Access Compliance Report

Public Rights-of-Way

(Pedestrian Signals)

Intersection ID: N/A	Main Street:	Cross Street: N/A	Location: N/A
ADA ID: 42CAD4A4E0BE	Signal Type: One Push Button-APS	Overall Compliance: No	Severity Score: BTN 1: N/A BTN 2: N/A No BTN: N/A
Codes/Mitigation Info/Possible Solution		Field Measurements/Component Compliance

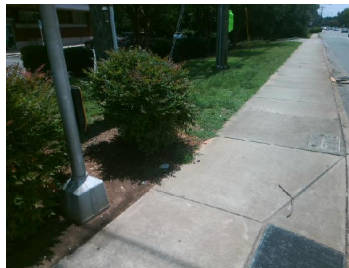
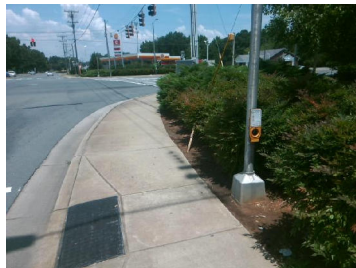
Surveyor Notes: TEXT HT 3/8

PROW/ADA: R410.6, TMUTCD 4e.08, R404.7.3, R209.1, MUTCD 4e.10

Possible Solutions: Replace Signal Push Button With APS Button on New Post. Remove & Replace Sign.
